ITEM: 6.4	REPORT SUMMARY MINOR VARIANCE APPLICATION FILE NUMBER A180/23
------------------	--

MINOR VARIANCE APPLICATION FILE NUMBER A180/23

CITY WARD #:	3
APPLICANT:	Angelo and Grace Fazio
AGENT:	Square Design Group
PROPERTY:	52 Lindbergh Drive, Woodbridge
ZONING DESIGNATION:	See below.
VAUGHAN OFFICIAL PLAN (2010) DESIGNATION:	Vaughan Official Plan 2010 ('VOP 2010'): "Low-Rise Residential"
RELATED DEVELOPMENT APPLICATIONS:	None
PURPOSE OF APPLICATION:	Relief from the Zoning By-law is being requested to permit a shed and swimming pool in the rear yard and increased maximum driveway width.

DRAWING
SITE GRADING
PLAN

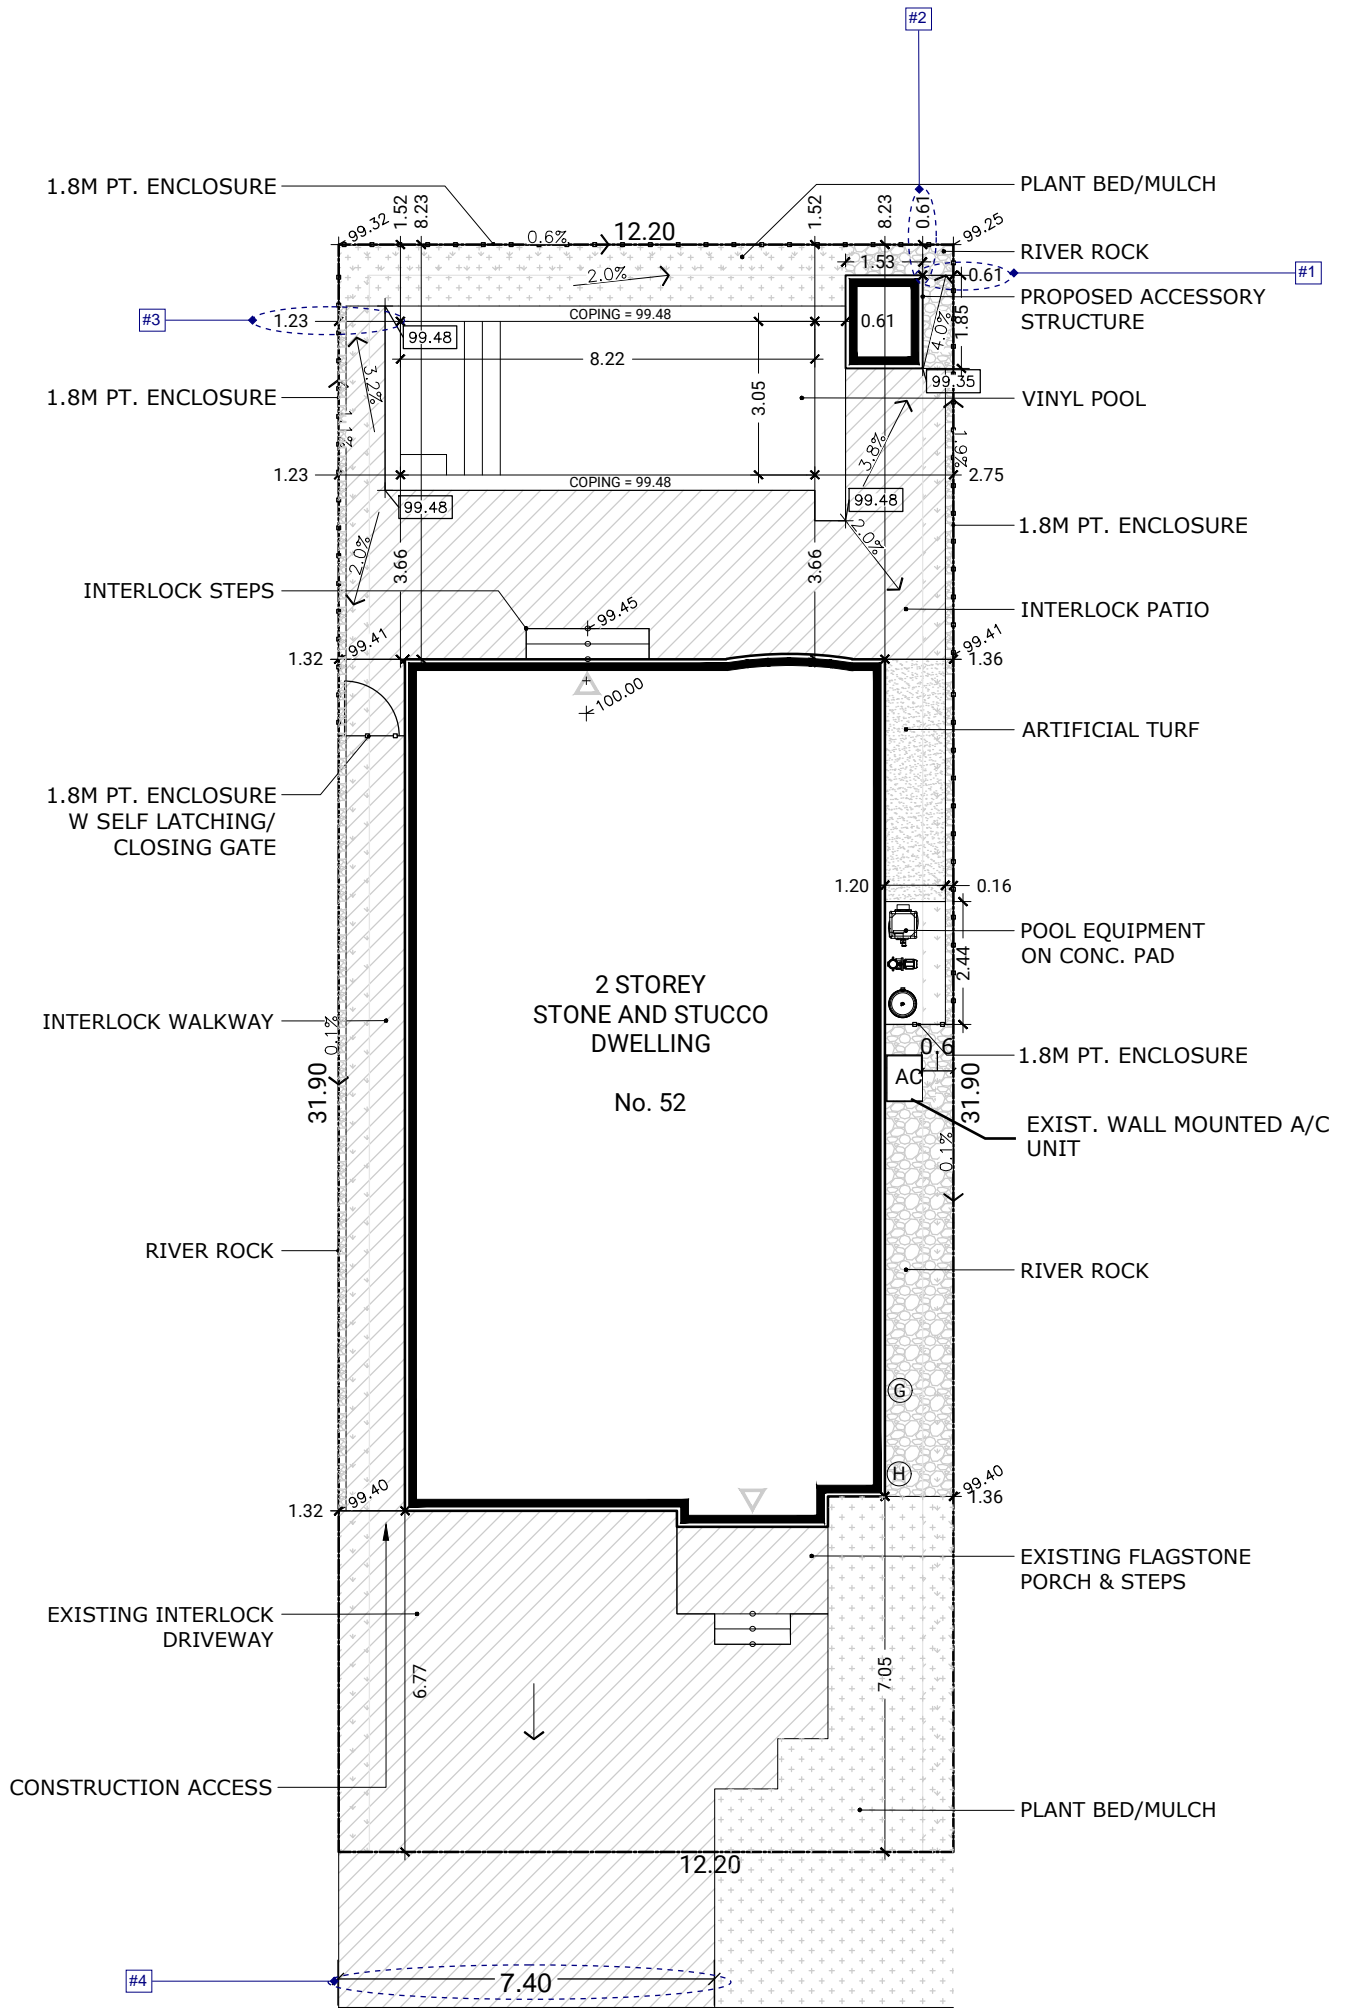
The Development Planning Department has no objection to Variances 1 and 2 for the rear and interior side yard setbacks for the shed. The shed complies with the height provisions of the Zoning By-law. Due to its modest height and size, the shed is not anticipated to pose adverse massing impacts to the neighbouring properties, and it provides an appropriate amount of spatial separation for maintenance access. The Development Engineering Department has also reviewed the proposal and is satisfied that drainage in the rear yard will be maintained.

The Development Planning Department has no objection to Variance 3 for the pool as the reduction to the interior side yard setback is minor in nature and not anticipated to be perceptible. The pool also complies with the rear yard setback requirements in the Zoning By-law and maintains an appropriate area for safe access and maintenance.

The Development Planning Department has no objection to Variance 4 for the driveway width between the street line and curb. The 7.74 m driveway width extends to the western interior side lot line and connects to the walkway that provides access to the rear yard. The 1.74 m increase in maximum driveway width is minor in nature and will not have adverse impacts to the existing streetscape.
